Addendum No. 1
To the Plans and Specifications of

**Escambia County Fire-Rescue
Paradise Beach – Station 20
1250 Bauer Road
Pensacola, Florida**

Three Pages + Attachment(s)
July 31, 2026

EM
FLOOR PLANS - POWER

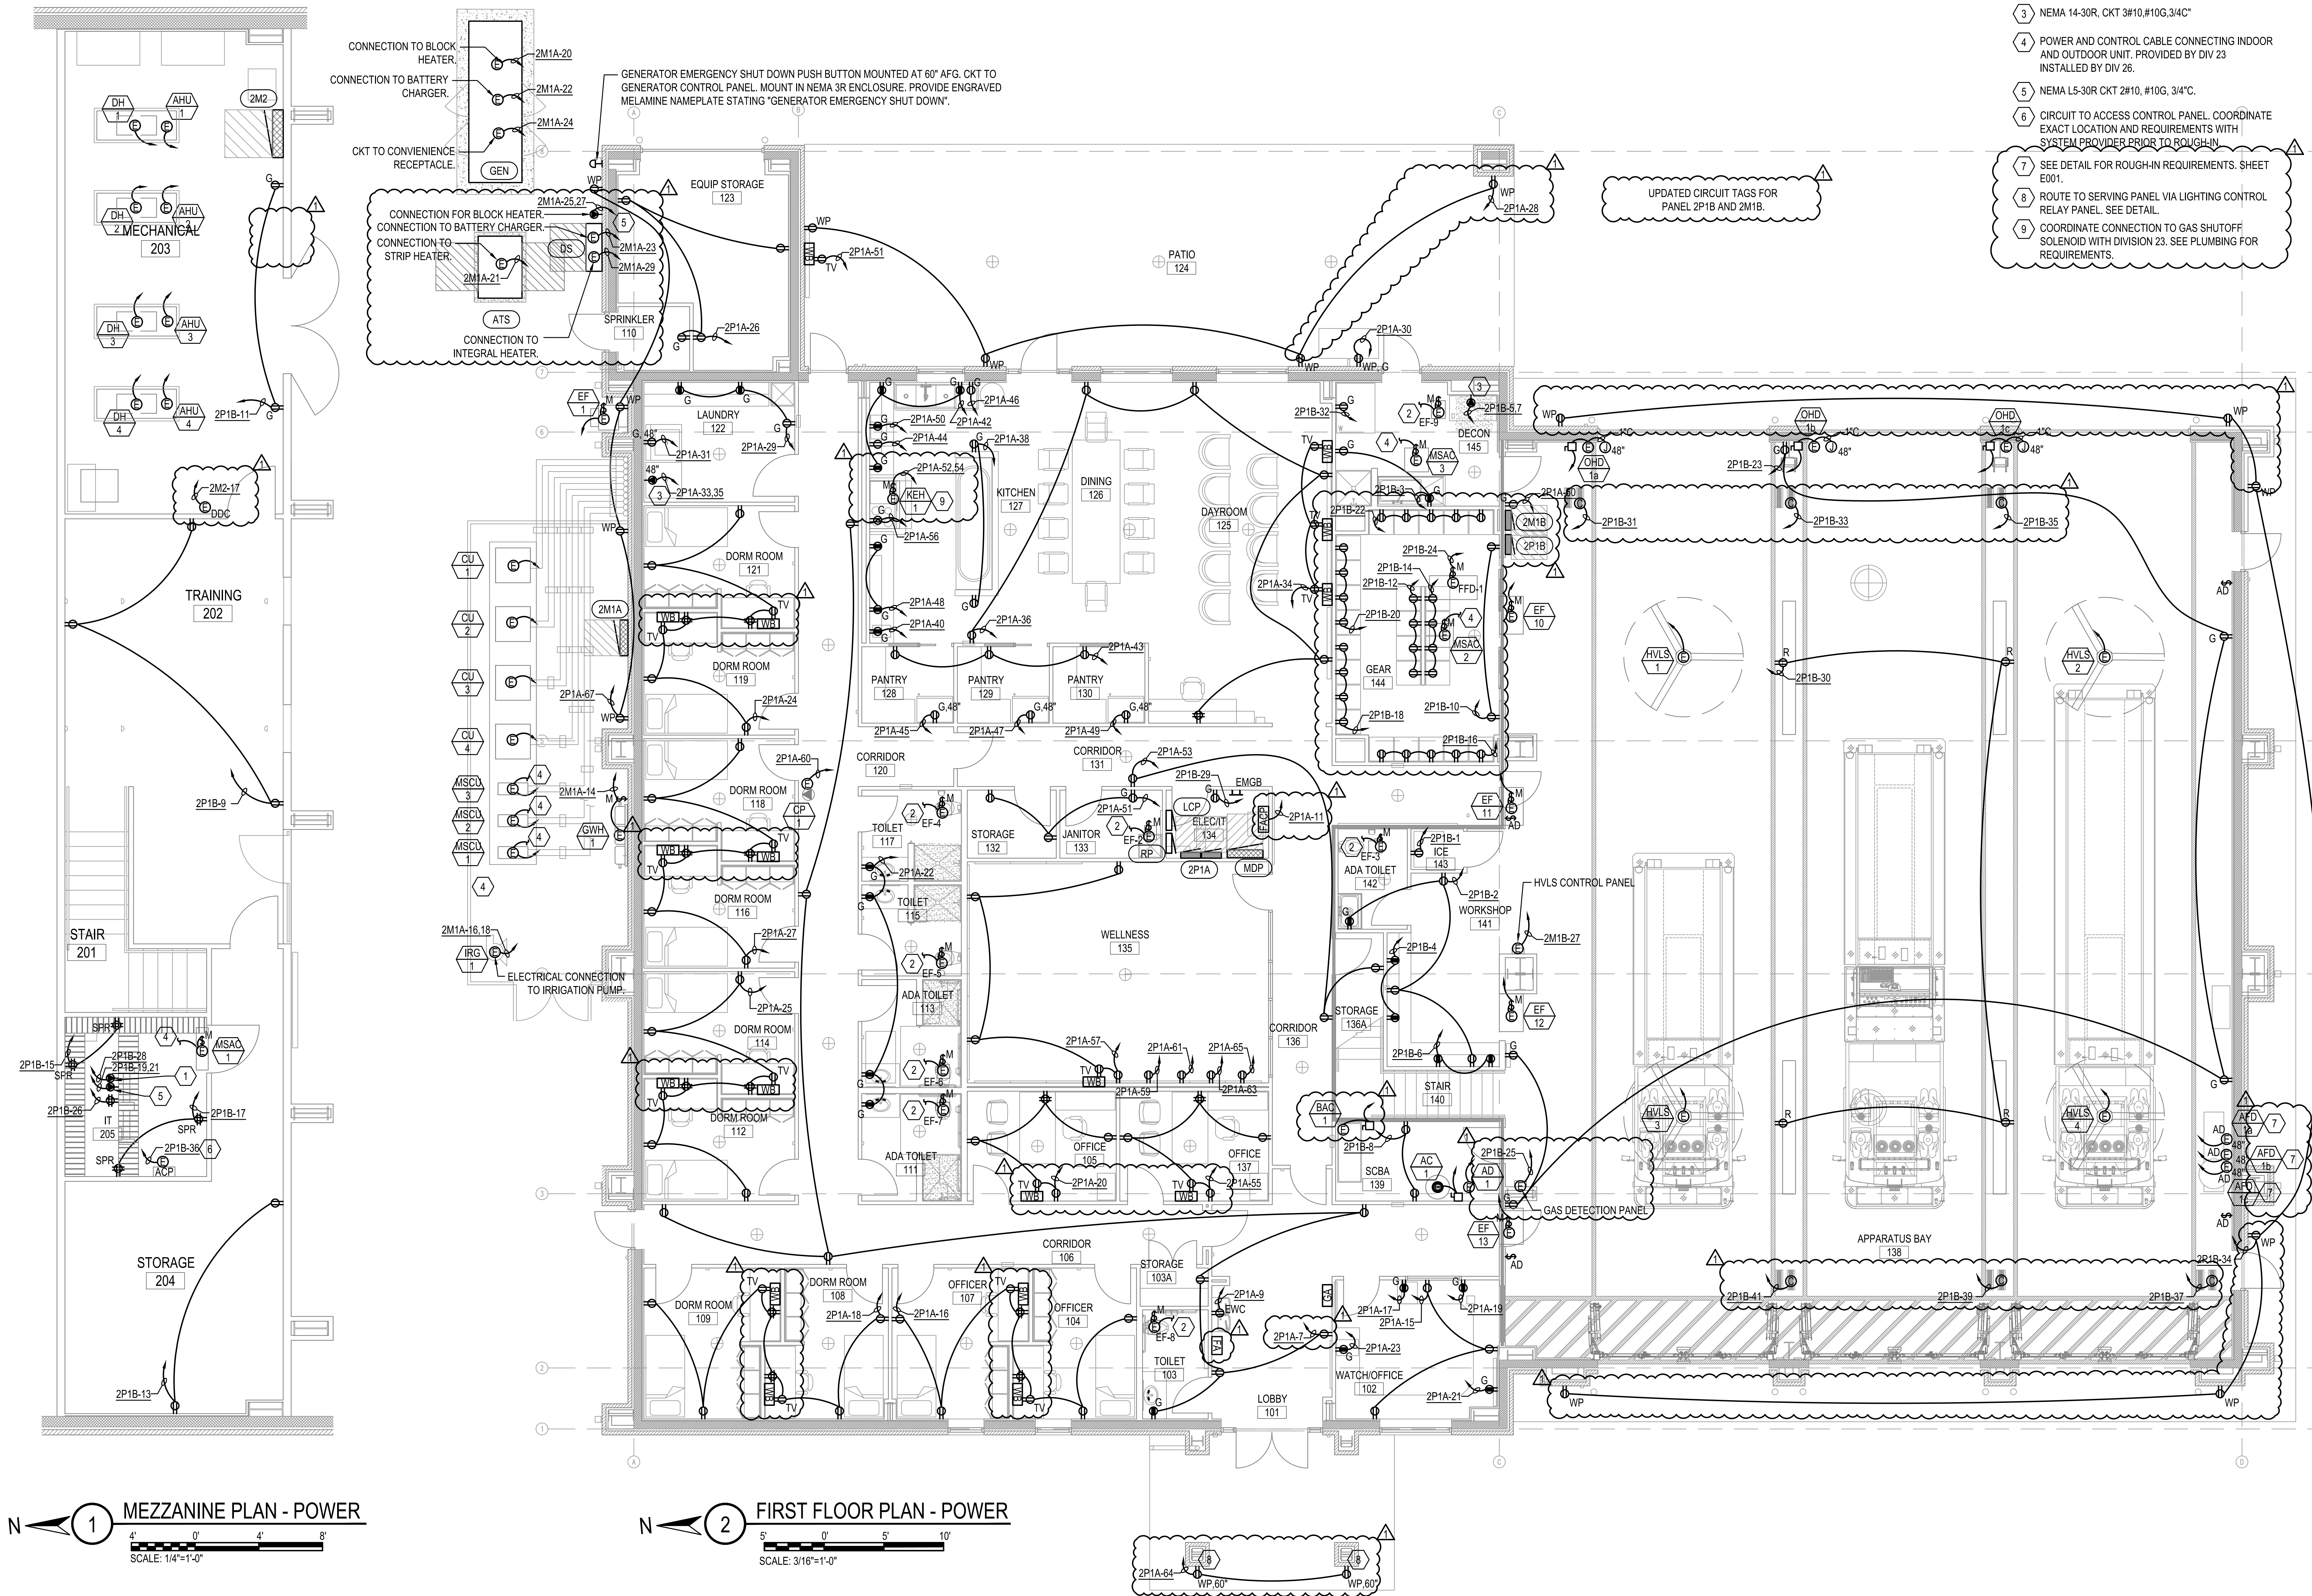
UPDATED CIRCUIT TAGS FOR
PANEL 2P1B AND 2M1B.
